Copy of Proposed Site – SUNY ULSTER

SUNY Ulster Concept Plan

Probable and Possible Wetlands (1 of 3)

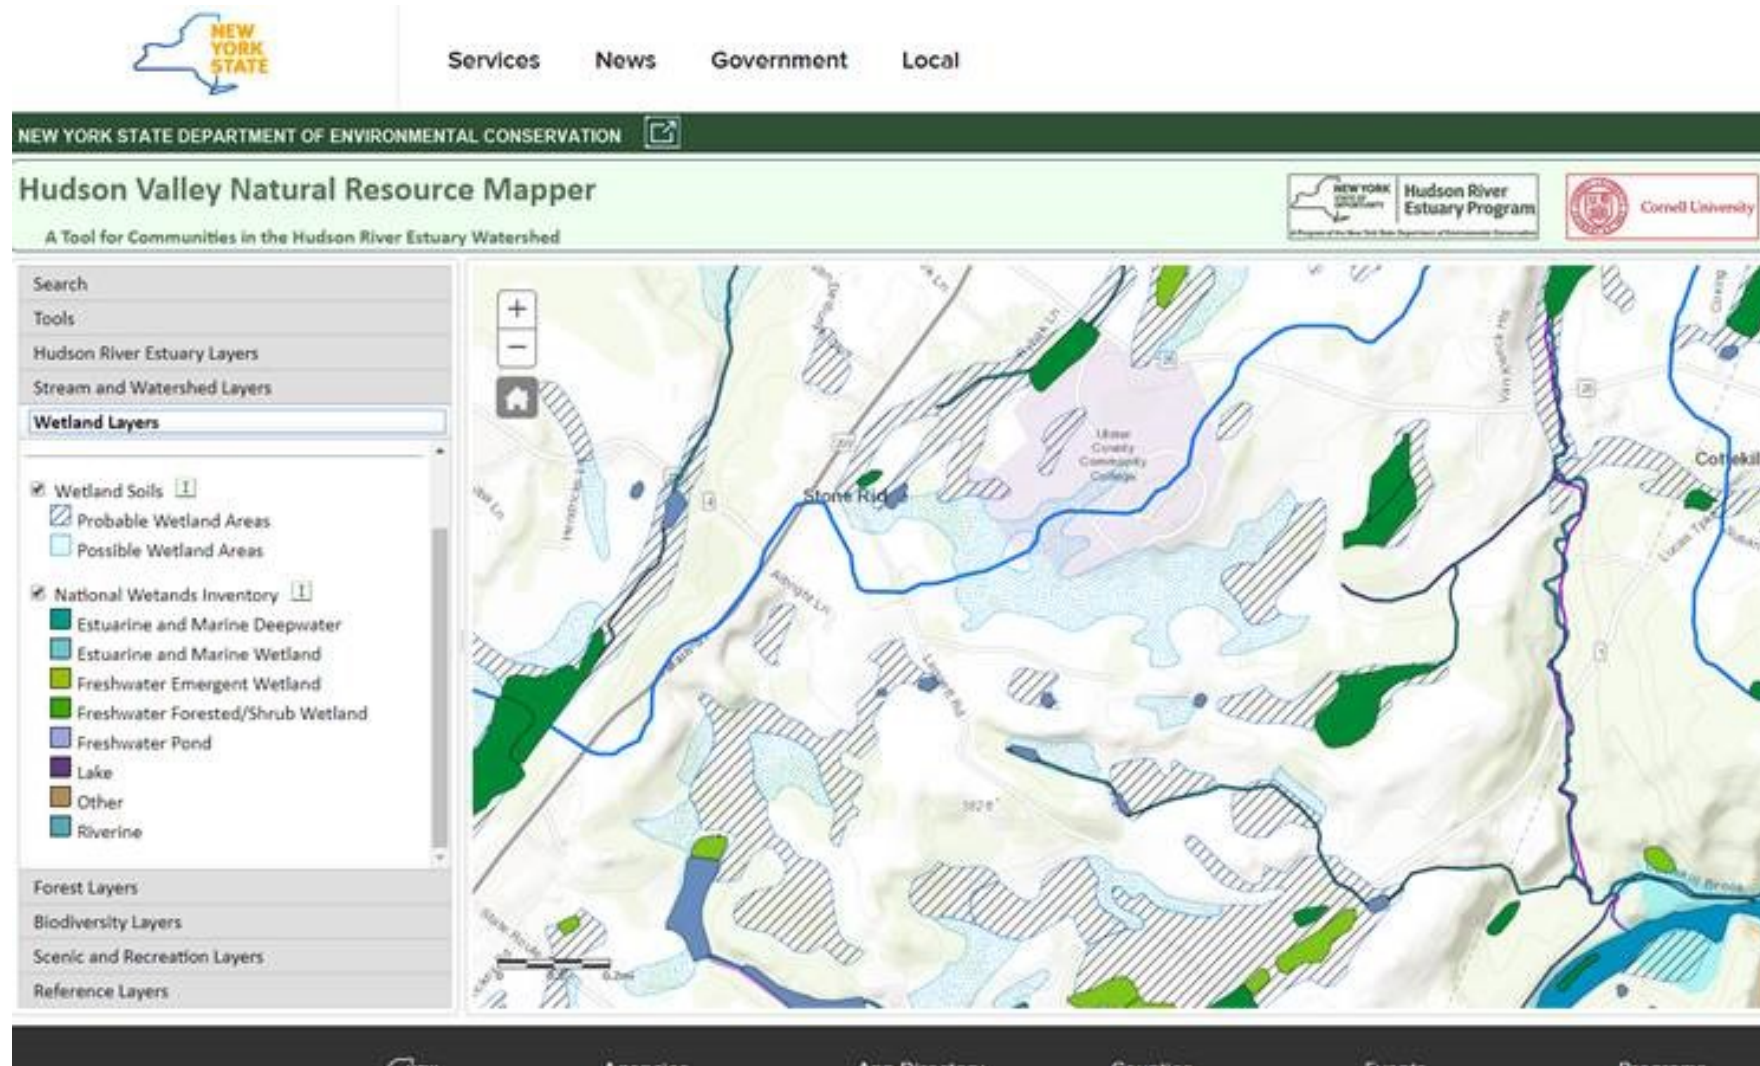
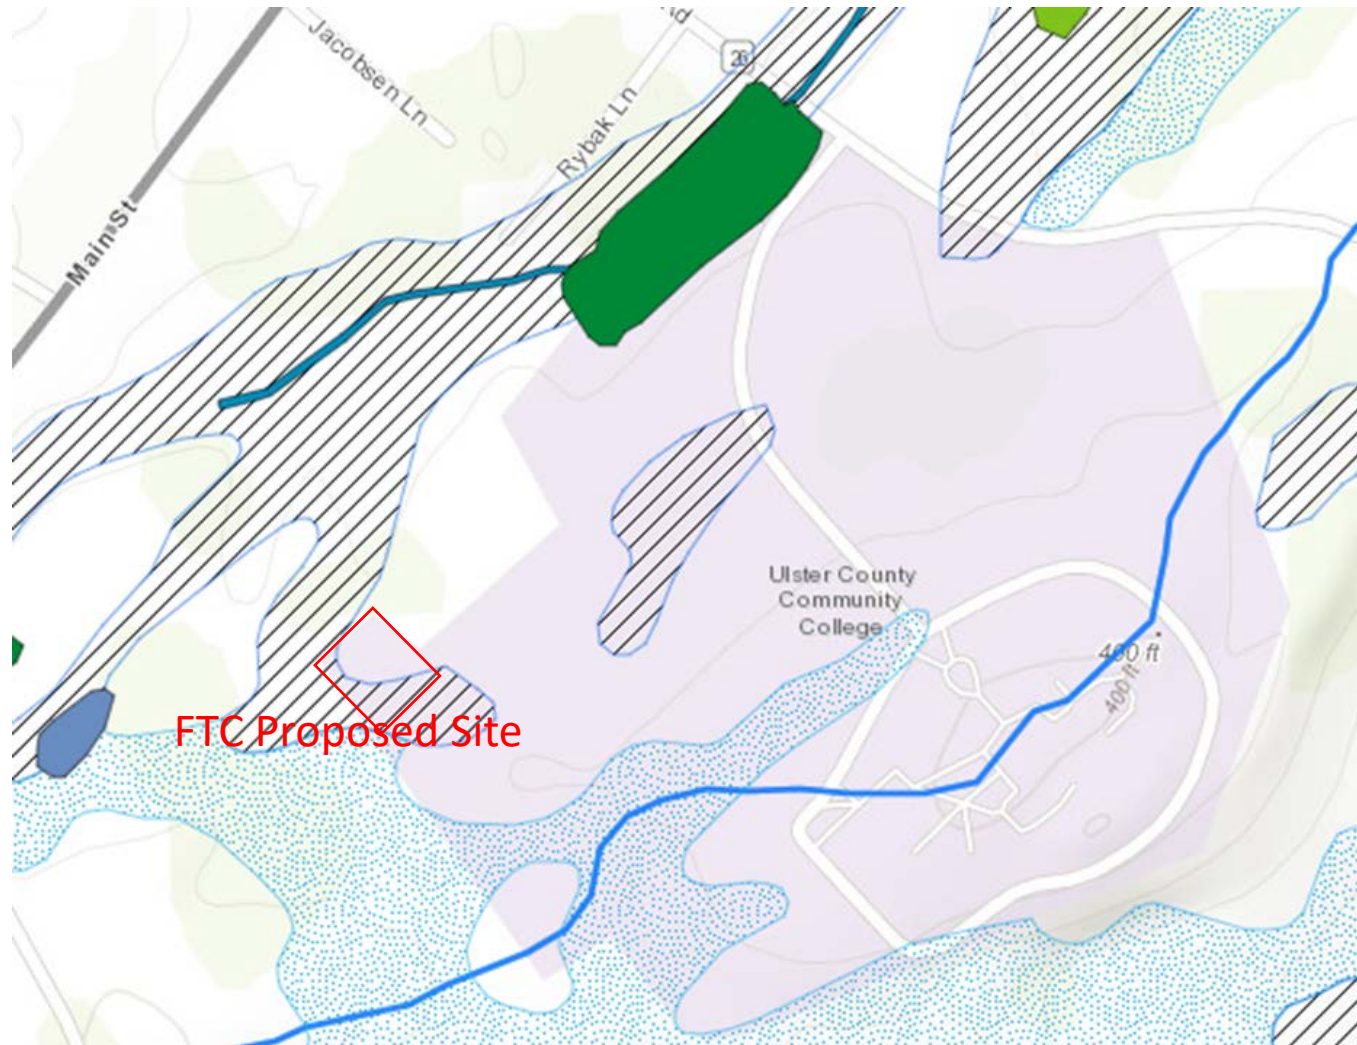
- ☒ Wetland Soils I
- Probable Wetland Areas
- Possible Wetland Areas

Description: Probable wetland areas
Mapunit Name: Canandaigua silt loam
Mapunit Symbol: Cc
Drainage Classification: Very poorly drained
Hydric: predominantly hydric
County: Ulster
Soil Survey Report Link:

NY DEC Site Map – Soil; Water area, Poorly drained

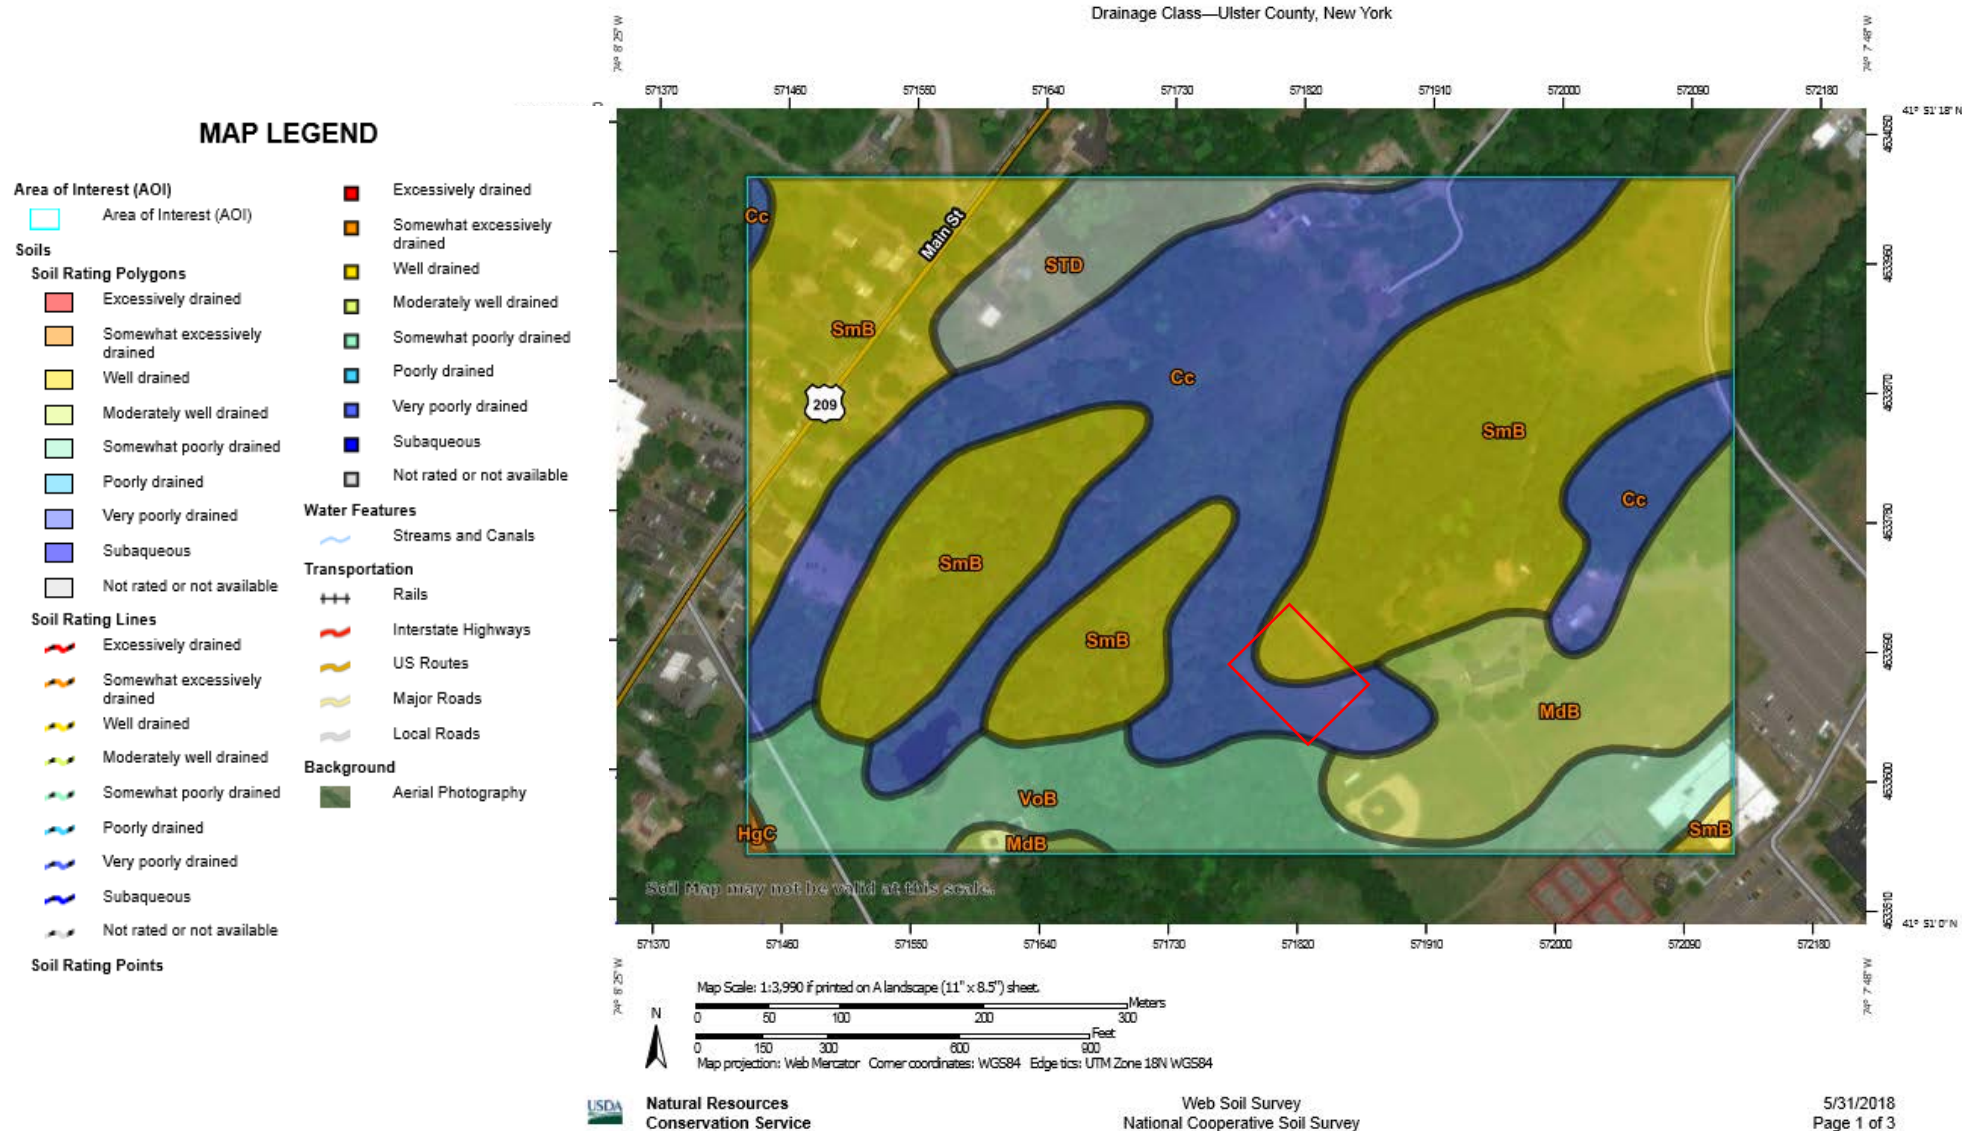
Parts of the Environmental Assessment Form: No mention of any possible wetland

Stockbridge Farmington	40 %	Volusia Gravely Silt Loam	40 %	Canandaigua silt loam	20 %
Stockbridge Farmington	40 %						
Volusia Gravely Silt Loam	40 %						
Canandaigua silt loam	20 %						
d. What is the average depth to the water table on the project site? Average:	_____ 4-5 feet						
e. Drainage status of project site soils:	<input type="checkbox"/> Well Drained: _____ 40 % of site <input type="checkbox"/> Moderately Well Drained: _____ % of site <input type="checkbox"/> Poorly Drained: _____ 60 % of site						
f. Approximate proportion of proposed action site with slopes:	<input type="checkbox"/> 0-10%: _____ 100 % of site <input type="checkbox"/> 10-15%: _____ % of site <input type="checkbox"/> 15% or greater: _____ % of site						
g. Are there any unique geologic features on the project site?	<input type="checkbox"/> Yes <input checked="" type="checkbox"/> No						
If Yes, describe: _____							
h. Surface water features.							
i. Does any portion of the project site contain wetlands or other waterbodies (including streams, rivers, ponds or lakes)?	<input type="checkbox"/> Yes <input checked="" type="checkbox"/> No						
ii. Do any wetlands or other waterbodies adjoin the project site?	<input type="checkbox"/> Yes <input checked="" type="checkbox"/> No						
If Yes to either i or ii, continue. If No, skip to E.2.i.							
iii. Are any of the wetlands or waterbodies within or adjoining the project site regulated by any federal, state or local agency?	<input type="checkbox"/> Yes <input checked="" type="checkbox"/> No						
iv. For each identified regulated wetland and waterbody on the project site, provide the following information:							
• Streams:	Name _____ Classification _____						
• Lakes or Ponds:	Name _____ Classification _____						
• Wetlands:	Name _____ Approximate Size _____						
• Wetland No. (if regulated by DEC)	_____						
v. Are any of the above water bodies listed in the most recent compilation of NYS water quality-impaired waterbodies?	<input type="checkbox"/> Yes <input checked="" type="checkbox"/> No						
If yes, name of impaired water body/bodies and basis for listing as impaired: _____							
i. Is the project site in a designated Floodway?	<input type="checkbox"/> Yes <input checked="" type="checkbox"/> No						
j. Is the project site in the 100 year Floodplain?	<input type="checkbox"/> Yes <input checked="" type="checkbox"/> No						
k. Is the project site in the 500 year Floodplain?	<input type="checkbox"/> Yes <input checked="" type="checkbox"/> No						
l. Is the project site located over, or immediately adjoining, a primary, principal or sole source aquifer?	<input checked="" type="checkbox"/> Yes <input type="checkbox"/> No						
If Yes:							
i. Name of aquifer:	Principal Aquifer _____						
<small>Note: result from DEC enviroMapper. All on-site evidence indicates that this is in error.</small>
